**DELAWARE RIVER JOINT TOLL BRIDGE COMMISSION  
EXECUTIVE OFFICES  
2492 RIVER ROAD  
NEW HOPE, PENNSYLVANIA 18938-9519**

**CONTRACT NO. T-668A, CAPITAL PROJECT 0301A  
THE SCUDDER FALLS BRIDGE REPLACEMENT PROJECT**

ADDENDUM NO. 8

**RESPONSES TO CONTRACTOR INQUIRIES SUBMITTED TO THE**  
**COMMISSION**  
**FROM NOVEMBER 16, 2016 THROUGH NOVEMBER 23, 2016**  
**INQUIRIES BY POTENTIAL BIDDERS**

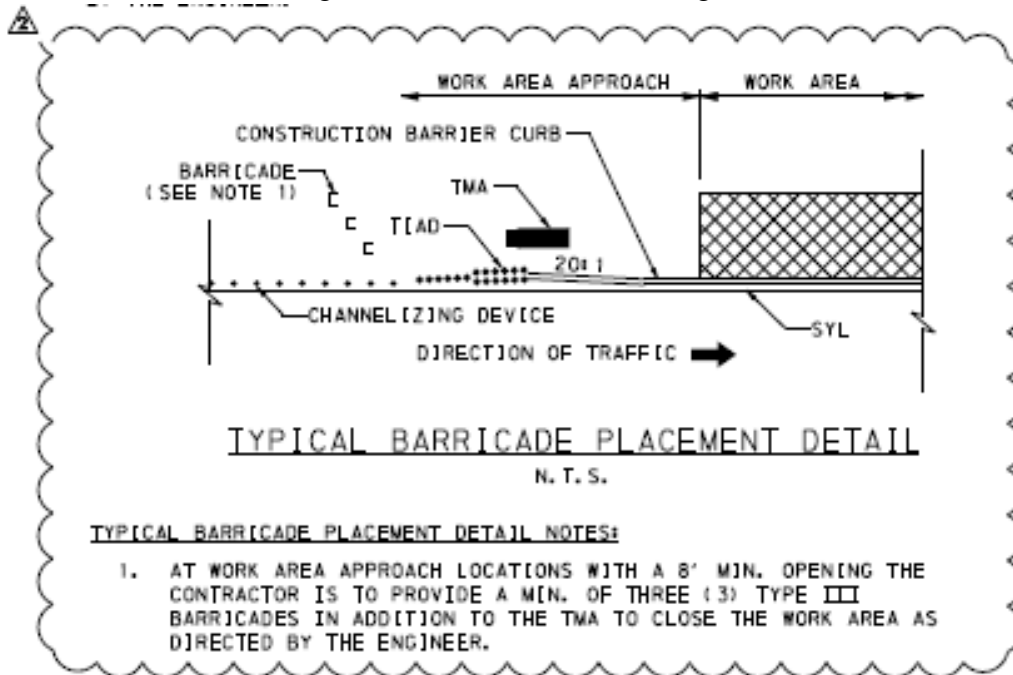
254. On Sheet 5 173 in Package A, Part 2, add the following detail:

Taylorville Rd. Bridge, S-36222

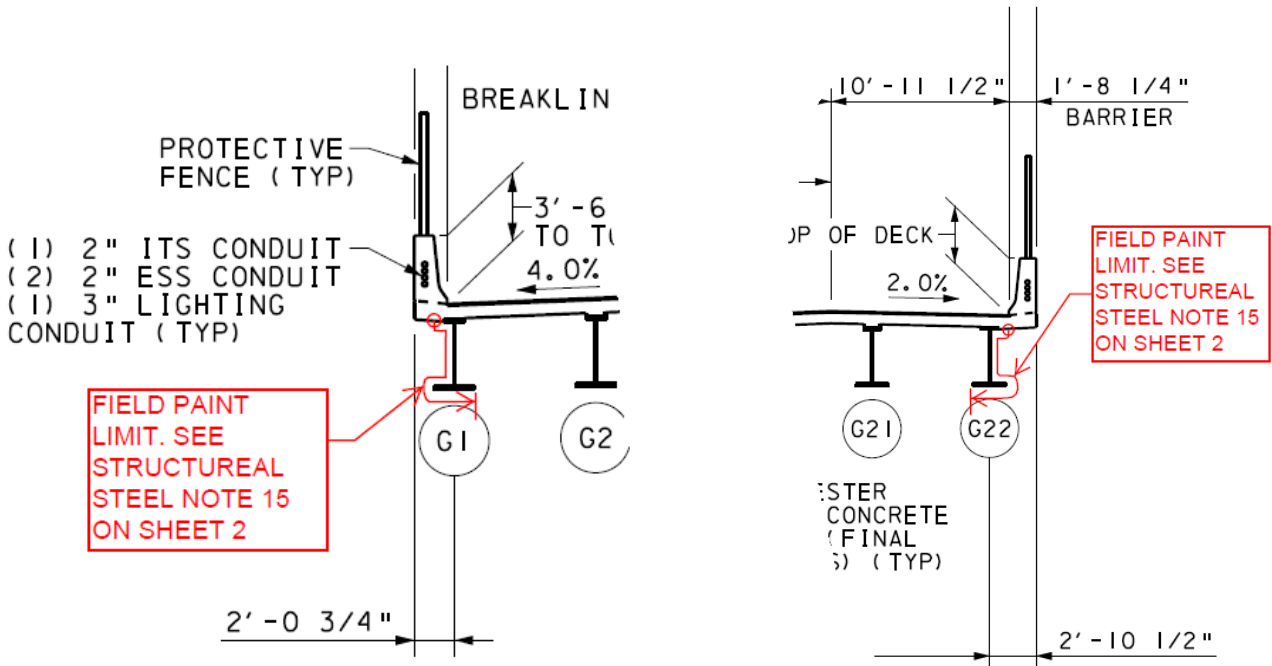
354. On Sheet 2 of 62 in Package A – Part 5, add the following STRUCTURAL STEEL note. “15. APPLY AN ADDITIONAL FINISH COAT OF PAINT TO THE EXTERIOR SURFACE AND BOTTOM OF BOTTOM FLANGES OF THE FASCIA GIRDERS (GIRDERS G1 AND G22) IN THE FIELD AFTER REMOVING THE OVERHANG FORMWORK SYSTEM. FIELD CLEANING AND PAINTING SHALL COMPLY WITH THE PENNDOT PUBLICATION 408, SECTION 1060 AND MANUFACTURERES’ RECOMMENDATIONS. THE COST OF PAINTING SHALL BE INCIDENTAL TO THE STRUCTURAL STEEL.”
355. On Sheet 4 of 62 in Package A – Part 5, add the following callout in the TYPICAL SECTION.
